RE: GP Aggregates, LLC. – West Farm Pit – Technical Revision No. 2 Request
File No. M-2008-078 – Response to Preliminary Adequacy Review

PROJECT NAME: West Farm Pit, DRMS File No. M-2008-078
PROJECT NO.: 11.124
FROM: Bonnie Schimmel, E.I.; Darin R. Duran, P.E. *DEJ*
DATE: September 23, 2013
SUBJECT: Response to DRMS Comments, Preliminary Adequacy Review
West Farm Pit Seepage and Rapid Drawdown/Slope Stability Analyses

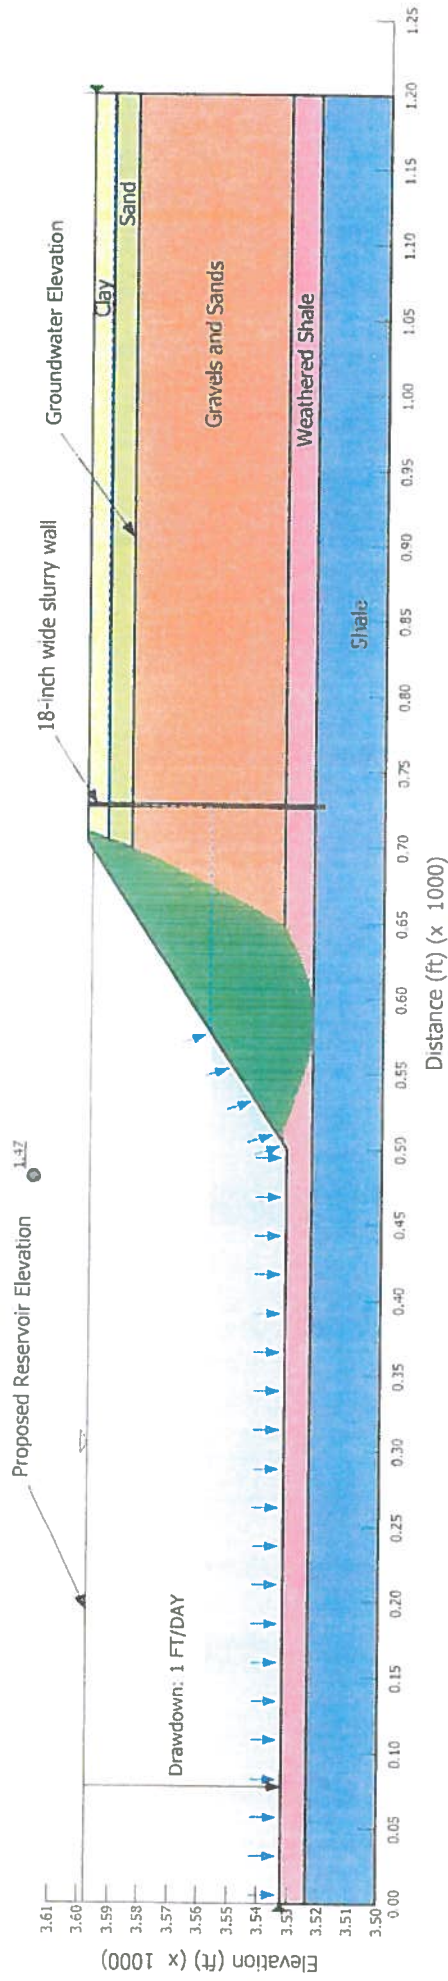
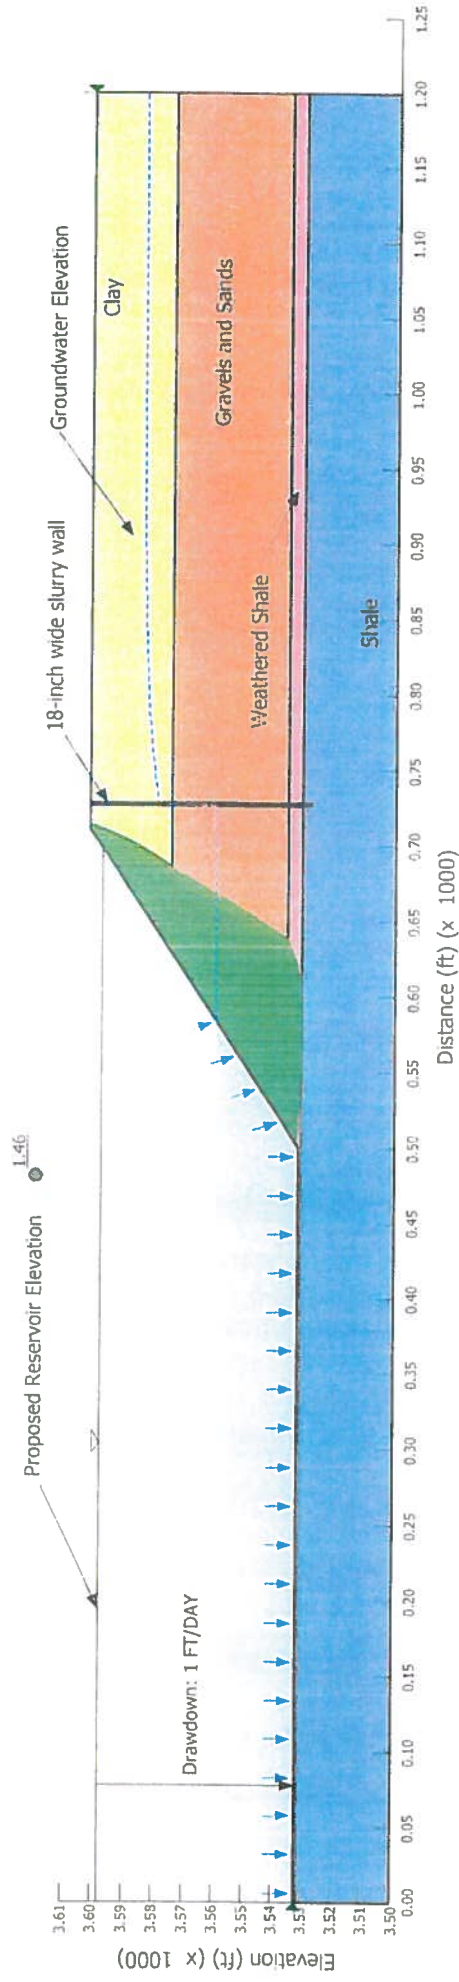
4. No stability cross-sections, section locations, or data runs from the analysis were included in the report. It is difficult to fully understand the geometry of the section being analyzed and the subsurface characteristics being evaluated without this data. Please provide a cross section location map, cross sections, and evaluation data for this analysis.

7. *The water level used in the analysis is stated as being at an elevation located at the top of the gravel/sand layer" for the analysis. The borehole logs indicate the water level (August 2010) is approximately 7-15 feet below the ground surface, in some cases several feet above the top of the sand/gravel layer. This water level may also not incorporate a seasonally high water level that would be expected during spring conditions, or with adjacent irrigation. Please address the adequacy of the stability analysis to model the seasonally high water level for this site.*

Item 4: We have provided cross sections, location map and stability runs from our March 21, 2013 analysis. These are printed and attached.

Item 7: We conducted a slope stability sensitivity analysis for groundwater at depths of 0 feet and 7 feet for both the thick clay and thick gravel cross sections and at 15 feet for the clay only. Rapid drawdown of the reservoir was analyzed with a drawdown rate of 1 foot per day. Pore pressures were computed using transient seepage analysis. Slope stability analyses were performed during drawdown which generated a minimum factor of safety versus time plot. The cross sections and results for the gravel section are attached.

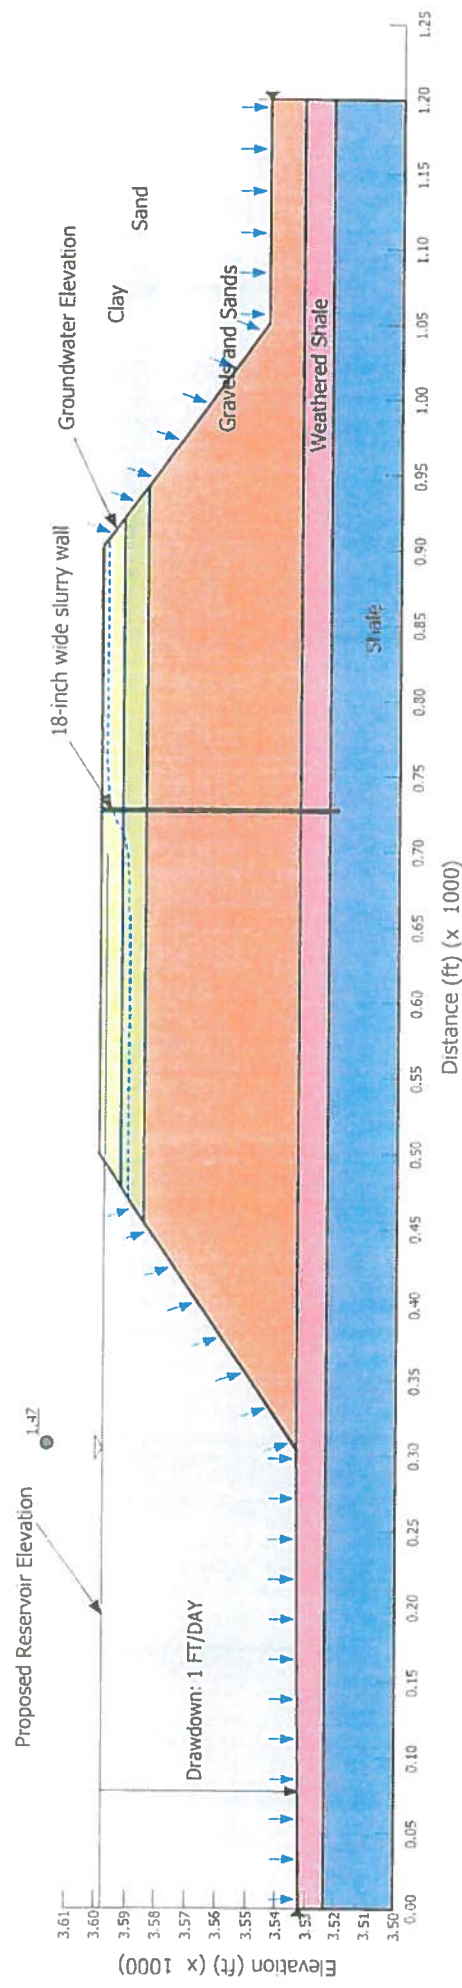
8. *The material properties used during the analysis, shown in Table 3, differ somewhat from the values used during previous stability analyses done in 2009 and with those used by DRMS. Please provide the basis for why these values were modified for this analysis.*

Item 8: The material properties used by J&T in the November 2008 report were presumptive values

based on assumed conditions. The values used for our stability analysis were based on laboratory testing of materials collected during the site specific study for the slurry wall. We conducted a sensitivity analysis to determine the effects of using the values assumed in the 2009 report. The factor of safety comparison is shown in Table 2.
